# SUNTOP SOLAR FARM

Modification Application 1

Development Consent SSD 8696

**JULY 2019**

FIGURE 1 SITE LAYOUT RELOCATED SUBSTATION AND ANCILLARY BUILDINGS

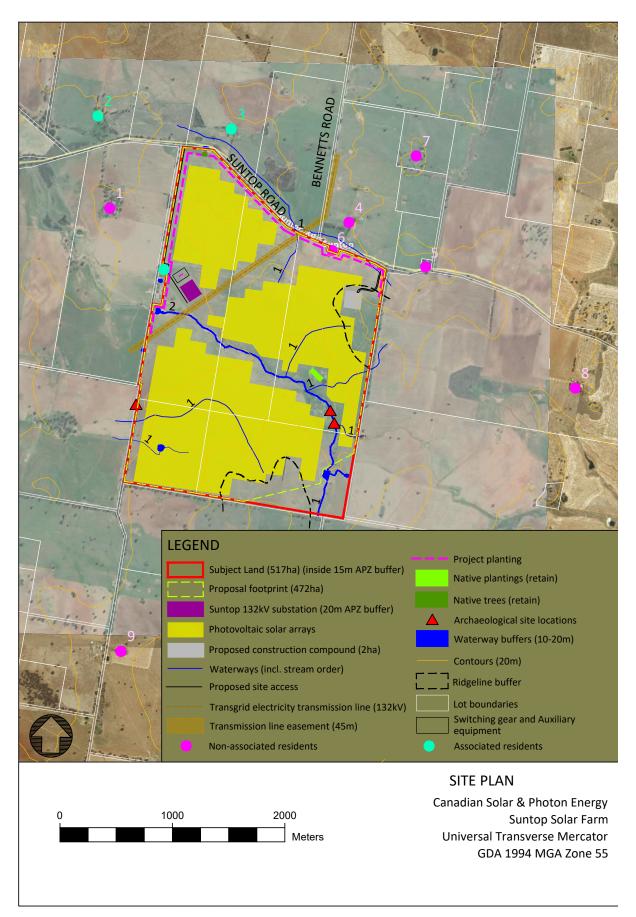
The substation is proposed to be relocated from its approved location and moved approximately 400m to the north east away from the existing waterway as shown below in Figure 1 and attached at Appendix 1. A comparison site plan showing the approved and proposed location of the substation is provided below in Figure 2 below and also attached at Appendix 1.

The modification proposes a minor change to the proposed vegetation screening along the western boundary to increase the screening for the revised substation location. Also shown in Figure 1 above and attached at Appendix 1. It is now proposed to implement a contiguous landscaped screen along the western boundary of the site from the front to the northern edge of the 132kV Powerline easement. Under the approved plan, this planting was infill planting only.

The modification also proposes a minor administrative change to the Site Plan. This change involves rectifying a minor drafting error in the location of the site boundary around the existing vacant dwelling on the Suntop Solar Farm Site. Due to the high-level scale of this plan, the boundary currently unintentionally excludes the dwelling from the site in the approved General Layout of Development Plan and the Green dot indicating this dwelling is incorrectly positioned. As detailed in the EIS assessment and several figures and other associated plans, the intention was always to include this dwelling in the solar farm site. To this end, the submitted Site Plan at Figure 1 below and at Appendix 1 has been updated to rectify this minor error by moving the site boundary to the south of this dwelling so it is included in the solar farm site and moving the green dot indicating the location of this dwelling into the correct position.

FIGURE 2: SITE LAYOUT PLAN SHOWING COMPARISON OF APPROVED AND PROPOSED SUBSTATION LOCATION

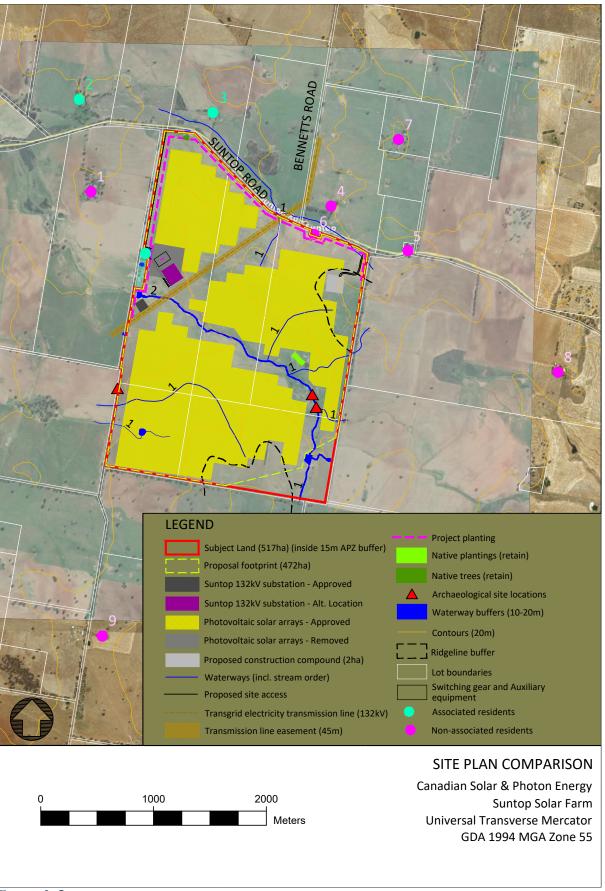
To further assist with understanding the changes associated with the proposed substation relocation, a comparison site plan has been provided at Appendix 1 and comparison plan showing a close up of the substation area is provided at Appendix 2. These plans show the original and proposed position of the substation area for the project to assist in understanding the changes proposed under this modification and their potential impacts. In additional an environmental impact assessment is provided below in Section 5 below.

FIGURE 4: PROPOSED MODIFICATION TO SUBDIVISION RELOCATING LOT FOR THE SUBSTATION AND CREATING AN ACCESS EASEMENT TO THE SUBSTATION (3 LOTS)

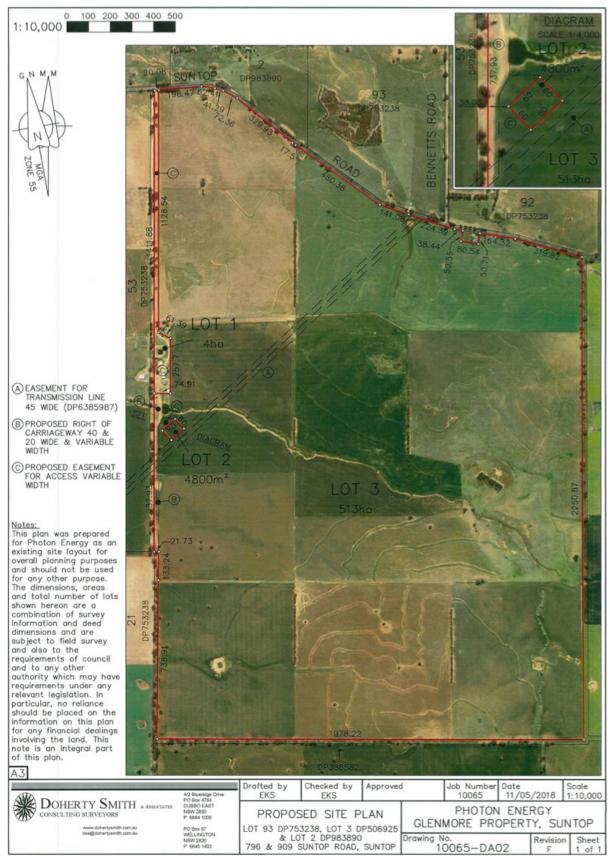
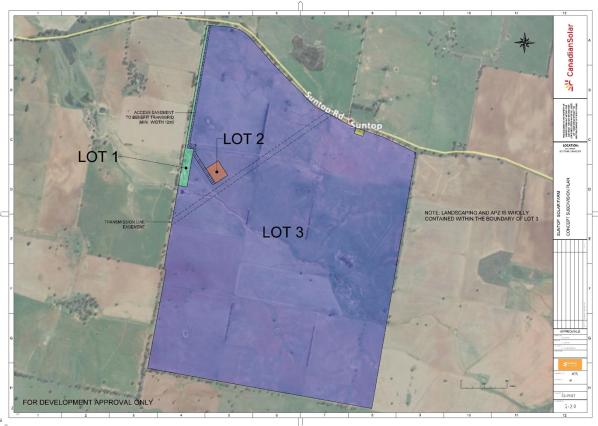
The originally submitted subdivision is shown below in Figure 3 below and attached at Appendix 3 for reference.

Subsequent to the Development Consent, the proposed substation relocation now requires a change to location and dimension of Lot 2 and TransGrid have advised they also require permanent right of access to the substation.

A revised plan of subdivision is shown below in Figure 4 and attached at Appendix 3 for reference. The subdivision is effectively a merging of the existing five lots (Lot 3 DP506925, Lot 122 DP753238, Lot 90 DP657805, Lot 2 DP506925, Lot 1 DP506925) into three lots as per the original Development Consent.

FIGURE 5 COMPARISON OF INDICATIVE LAYOUT FROM ORIGINAL APPROVAL VERSUS PROPOSED LAYOUT FOR MODIFICATION

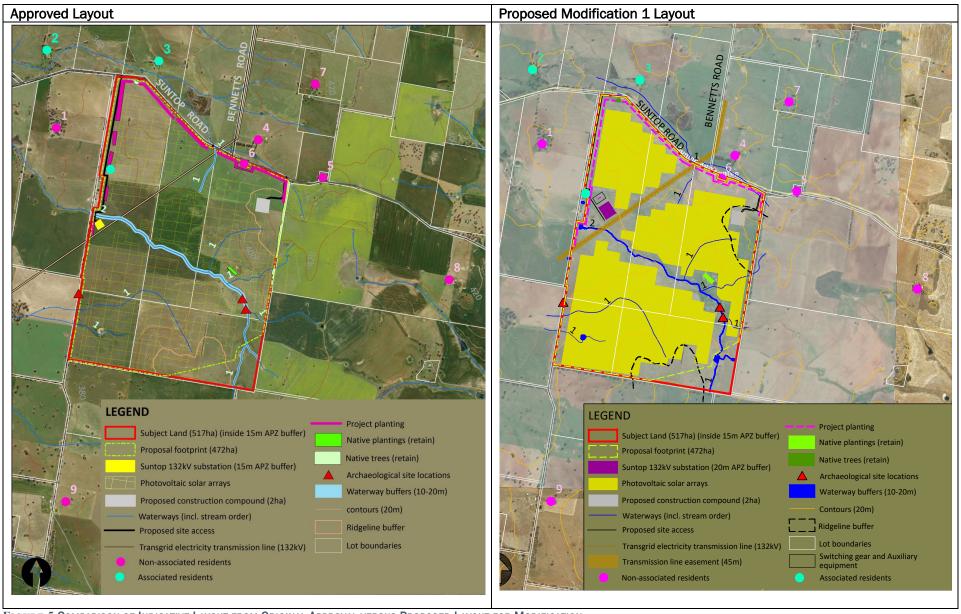
Table 1 below provides a comparative analysis between the approved development and the development in the proposed modification. In addition to the above comparison plan at figure 2, an extract of the site layout and proposed modified layout are provided side by side below at Figure 4 for reference.

land areas are significantly larger than
		what will be required for the final footprint
		of the substation and Switching gear and
		auxiliary equipment. The key change in
		terms of indicative footprint is the addition
		of between 2 and 4 additional shipping
		container style buildings which will serve
		as switching station/auxiliary buildings. It
		is noted that the substation and switching
		gear and auxiliary equipment are being
		located in areas that are currently
		occupied by a solar array under the
		approved layout. On this basis the
		footprint of the overarching project is not
		being increased.
		The relocation also requires the access
		road to this infrastructure to be moved to
		provide ongoing access to the substation.
		In addition, since the granting of the
		Development Consent, Transgrid has
		requested this access be formalised as an
		easement.
		The relocation allows for improved access

without impact on the existing waterway &
		increased setbacks from the waterway.
		The proposed substation infrastructure in
		its relocated position will occupy an area
		that was designated as solar photovoltaic
		arrays in the approved General Layout
		Plan.

Project	Originally Approved	Proposed Modification
Element	Development	
		Only part of the security fence for the substation will project outside of the original indicative footprint for the proposed solar field. This is evident in the Comparison Layout Plan of the approved and proposed layouts provided at Appendix 2 for reference. This is a negligible change with no potential for adverse environmental or amenity impacts given its location within the site and being a farm paddock set well away from any sensitive receivers.
		The modification also proposes a minor administrative change to the Site Plan. This change involves rectifying a minor drafting error in the location of the site boundary around the existing vacant dwelling on the Suntop Solar Farm Site. As detailed in the EIS assessment and several figures and other associated plans, the intention was always to include this dwelling in the solar farm site. To this end, the submitted Site Plan at Figure 1 below and at Appendix 1 has been updated to rectify this minor administrative error.

FIGURE 2: PROPOSED MODIFIED SUBSTATION LOCATION (provided by EnergyForms, 19 July 2019)

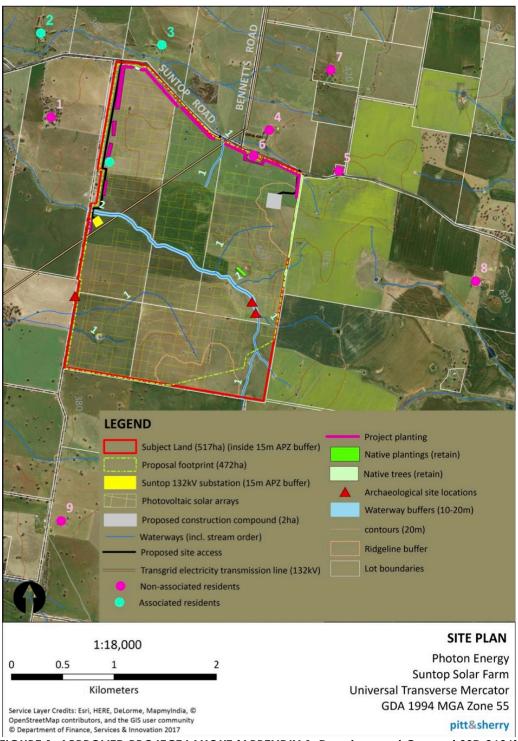
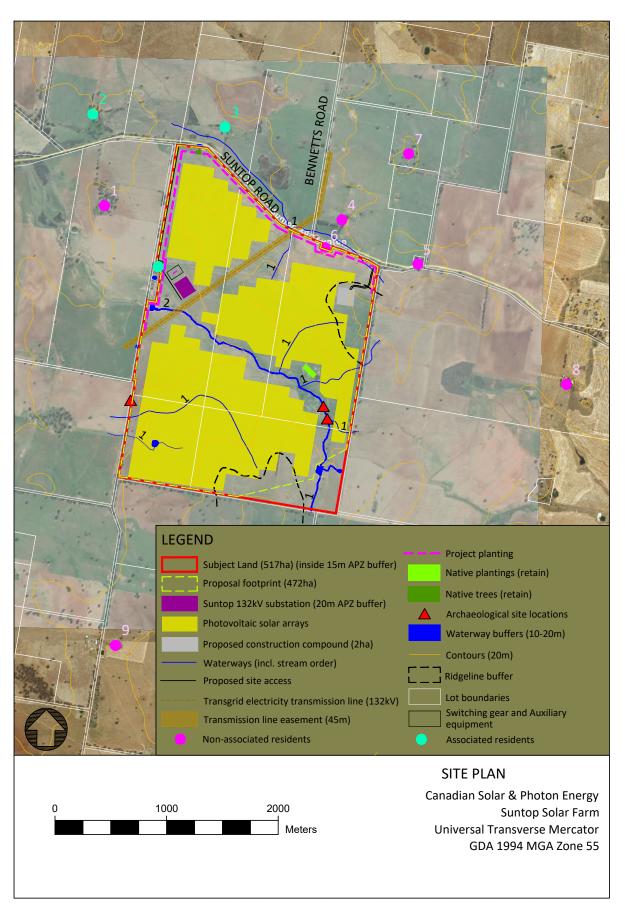
The approved position of the substation is shown **FIGURE 1** (Appendix 1 of the Development Consent).

- the relocation of the substation to the north west side of the Transgrid transmission line and north of the waterway. The proposed modified position of the substation is shown **FIGURE 2**.

- Separation of the substation into two key components being:
  - The main substation containing the transformer(s) and connection into the grid (shown in red on **FIGURE 2**)

- The E-house containing up to 4 X 40ft containers to house medium voltage (MV) and low voltage (LV) switchgear as well as auxiliary equipment (shown in blue on FIGURE 2).
